Woodside Sellman Project Items

WRNS STUDIO Design Team Cooling Strategy and Air Conditioning

November 4, 2016

Original Structural Design

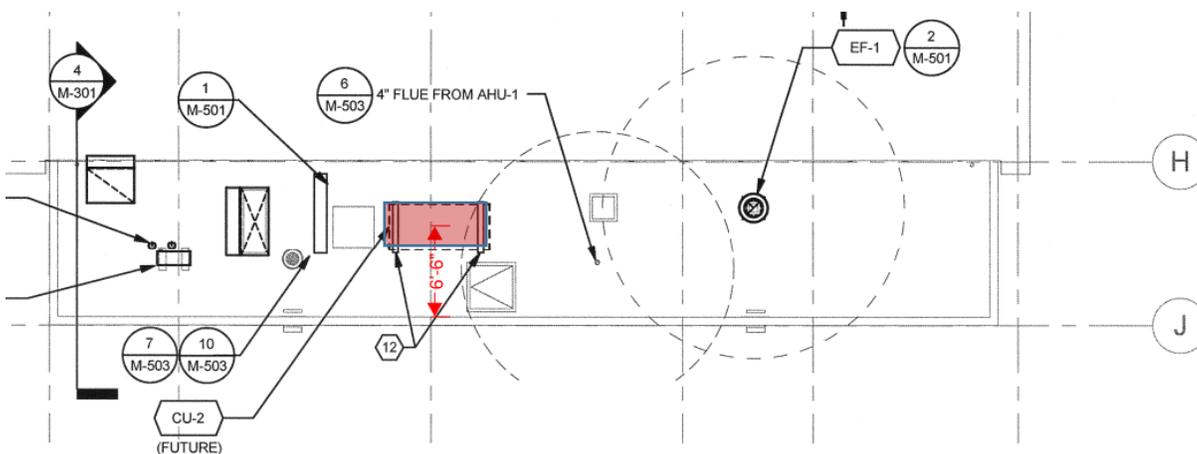
Our original design included a requirement for larger support beams at locations of any condensing units. If these beams were installed at the new chiller location, then we will be fine. However, I suspect that is not the case, and the existing framing will need to be strengthened. Alternatively, chiller should be moved to location where the beams were installed, i.e. the location previously identified as "future condensing unit".

Proposed new location: **blue** box is revised CA location based on CA input; **yellow** box is current suggested location

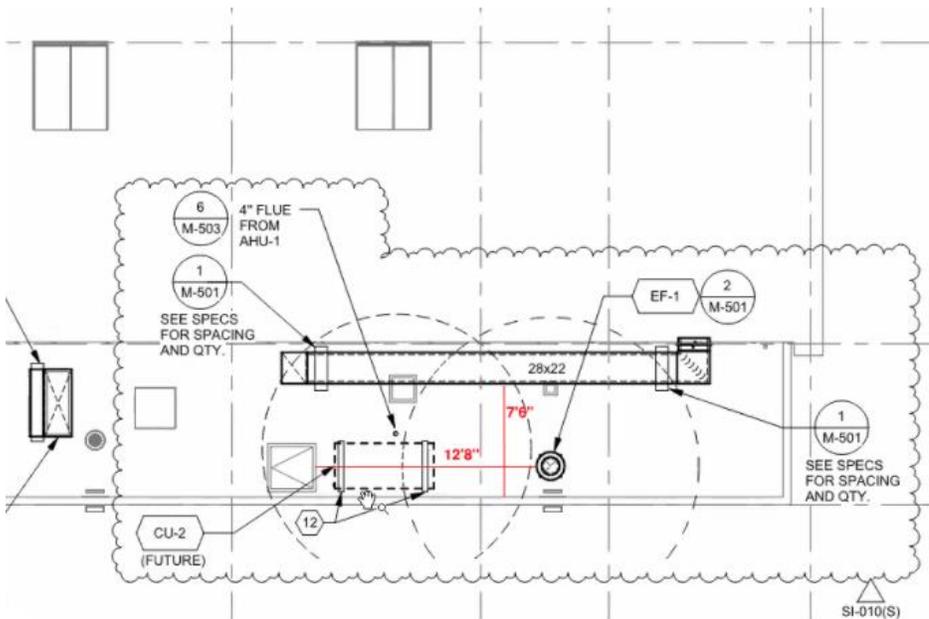
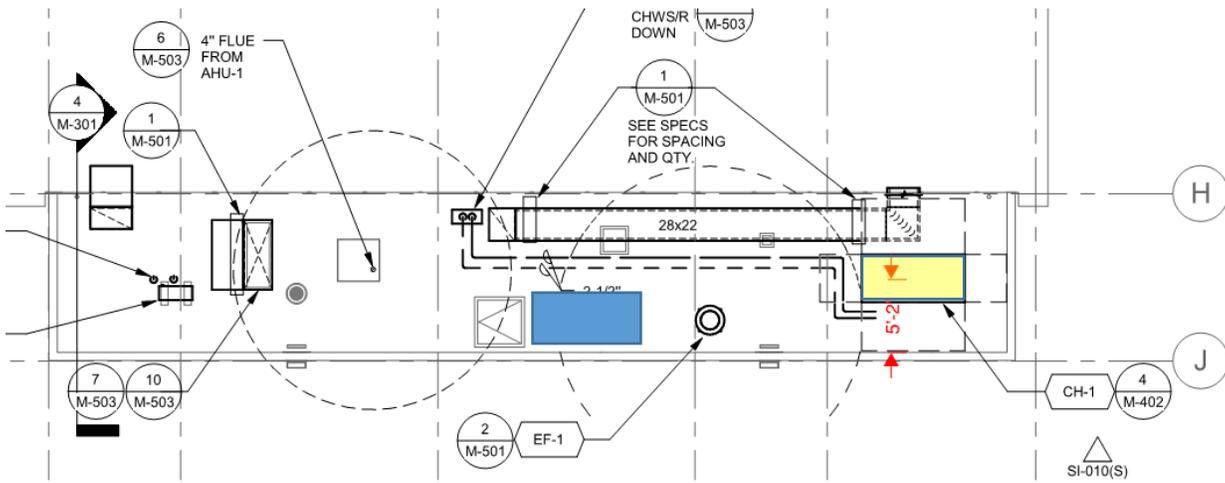
Structural has reviewed the mechanical design and indicates that the addition of the chiller will result in the need to reinforce the gravity system (i.e. strengthening of roof joists and adding blocking) given the new location. Potentially we could accomplish this by sistering new 2x's to the existing joists. The particulars will be worked out during design once the location of the chiller is confirmed. We believe that the most cost effective way to access the structural members if from the roof top which would mean reroofing the portion removed. The original design required the increase in

strengthening only below the condensing units (to minimize costs). Given that the unit was moved, it is unclear if added structure was included in the new location identified during Construction Administration and noted as "Future Cooling Unit". See Structural diagram of existing condition below

Original BOD (before relocation) : **red** box is shown as designed

RFI 204: 10/2015

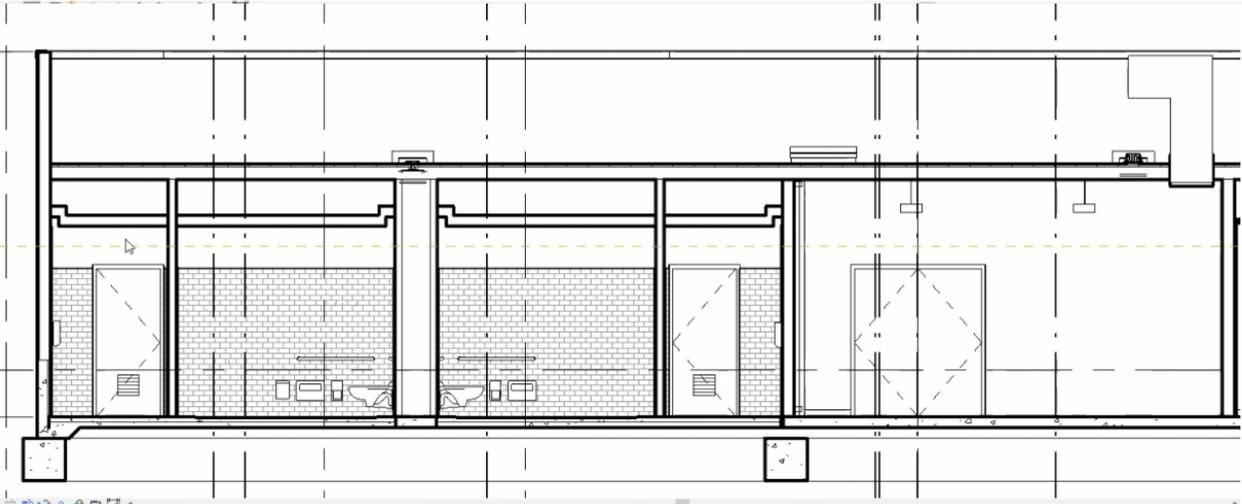
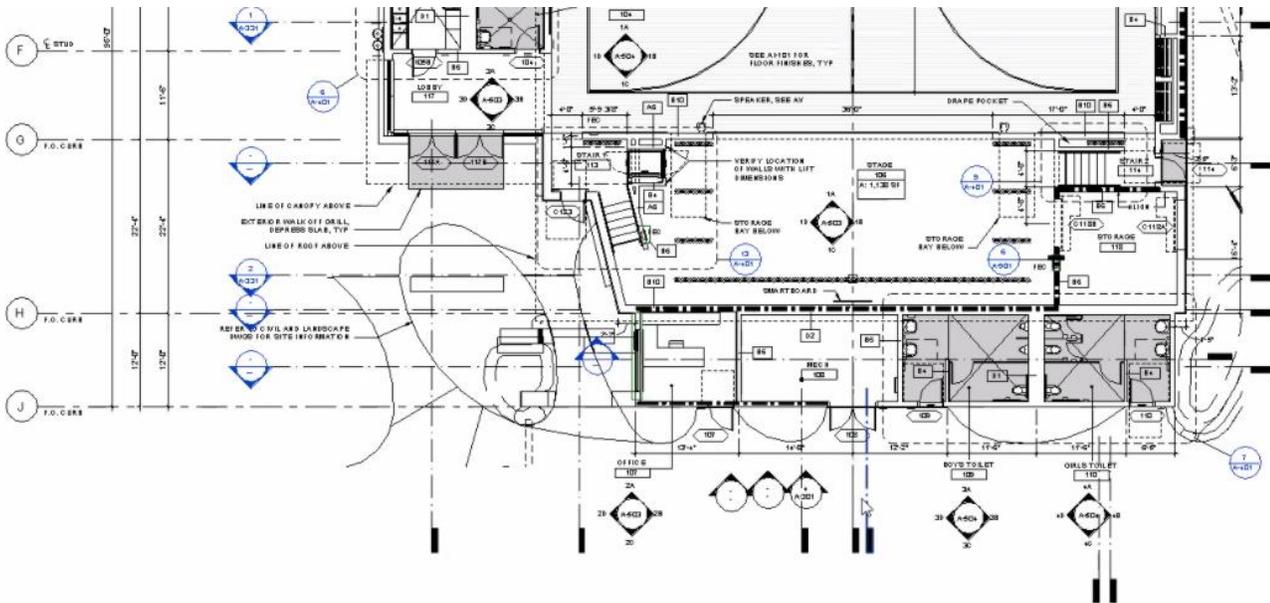
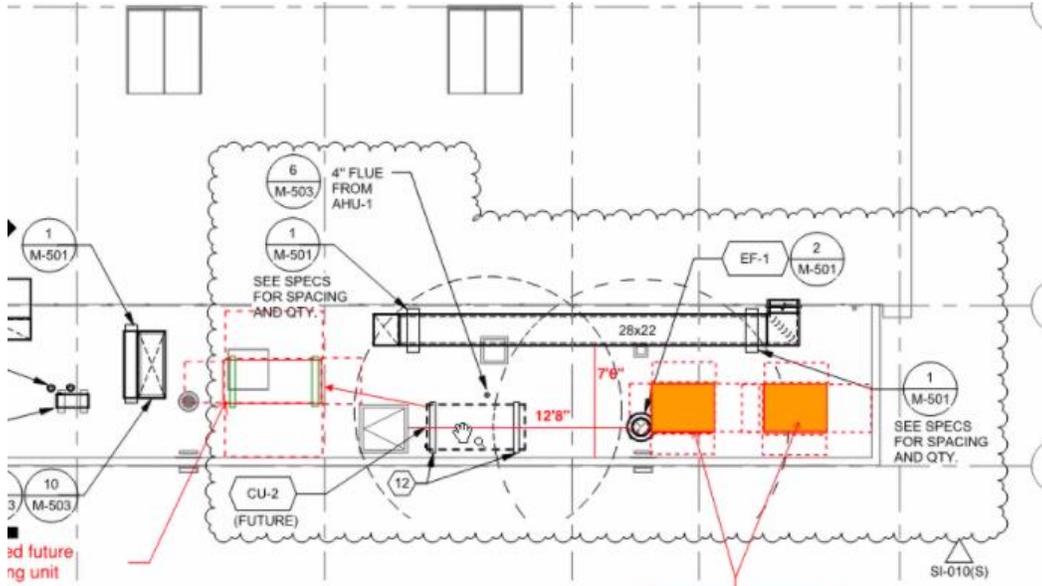
- 1) 50"x18" Supply air duct discharge has a conflict with 4x4 post, which is approx. 6' from mechanical room. Please advise how to extend the ductwork passing thru this post.

- 2) 28"x18" R/A duct does not fit in space. Clear dimension of duct with 1"-insulation will be 30"x20". There is 17" clear depth over boys and girls bathroom & 14" clear depth between both bathrooms. If we decide to run the ductwork over the roof due to ceiling space restrictions, Future CU-2 & EF-1 need to be relocated. Please advise.

- 3) MD-3, 4 & 5 are 20 round damper which can not be installed if duct work is 50"x18" (see #4). Please advise.
- 4) Please confirm per conversation with Jesse (Interface) to run 50"x18" supply air duct in lieu of 48"x22".

- 5) Return air duct between G&H, J&H/2, 3 & 4 is too close to the wall and there is not enough room to hang duct per SMACNA standard. min. 4-6" clear space is required for starp/support.

- 6) Note No. 5 on sheet M-201, range hood discharge to hood. What size? Please advise.
- 7) What size grille are in the kitchen and toilet 104? There are no sizes or schedule. Please advise.

- 8) 60"x24" outside air duct over air handler 3/Mechanical room Enlarged plan does not show insulation. Is it required to have insulation? If yes, how many inch? Please advise.

Base unit dimensions — 30RAP018-030

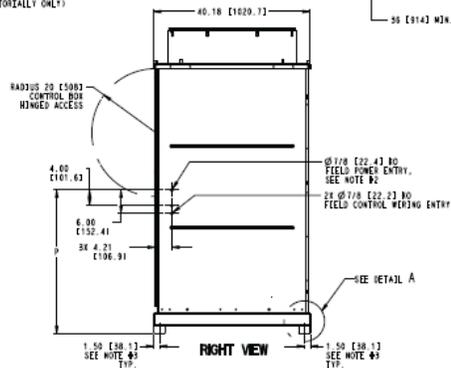
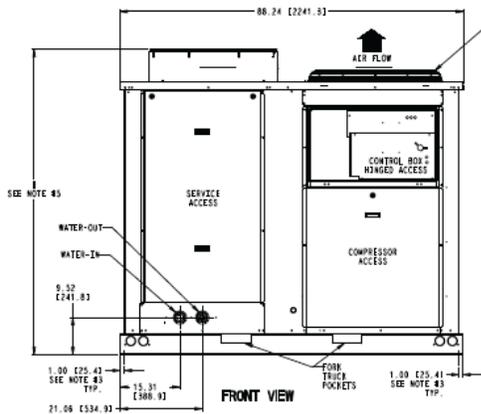
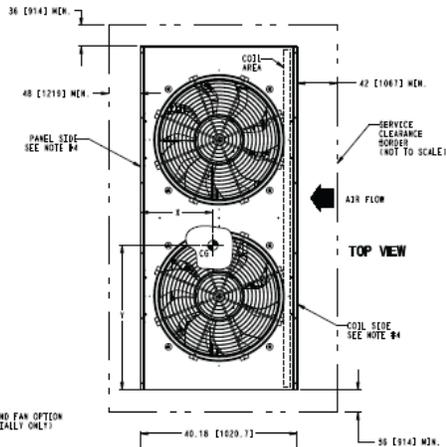
Air cooled chiller with 25 tons of capacity (Carrier 30RAP); approximately 88" wide, 40" deep, and 73" tall. The unit is 1405#, and the curb can be sleepers. Chiller cut sheet which indicates 8 mounting points (4 per side).
